## USB72x6/USB7252 Silicon Errata and Data Sheet Clarification

This document describes known silicon errata for the following USB72x6/USB7252 devices:

**FIGURE 2: TYPE-C DISCHARGE WORKAROUND FOR MODULE 3**

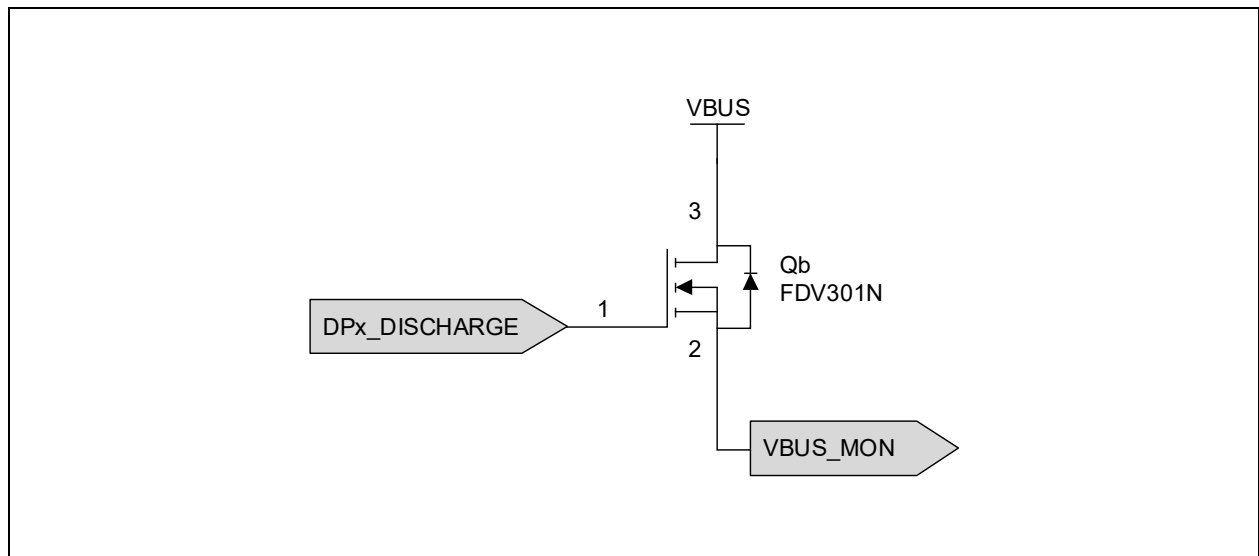
Frequently, these ports will be implemented with electrolytic VBUS load capacitors, which retain a small residual charge that is released slowly compared to the timing of the discharge. In such cases, as energy is released from the capacitor the voltage can drift upward slightly after the discharge, which can cross the VBUS\_DET threshold for detecting VBUS high. In the sequence of the Port Power On/Off test, this can inhibit subsequent turning on of VBUS in response to commands from the test host and the test fails.

Type C ports that have a large electrolytic capacitor may require this workaround to pass the HUBCV Port Power On/Off test.

In reference designs for USB7216 and USB7252 devices, an N-channel MOSFET with a  $V_{GS}$  less than 1.0V is connected between VBUS and VBUS\_MON, with gate control from the DISCHARGE signal. This additional component creates an additional current path as the discharge is monitored by VBUS\_MON, which biases VBUS\_MON higher. This results in discharge to a lower voltage than what is otherwise achieved, and compensates for any residual energy that the capacitor releases after the discharge. At times other than the discharge, the MOSFET is turned off and does not influence VBUS.

No components of the reference design need to be removed; only the MOSFET is added.
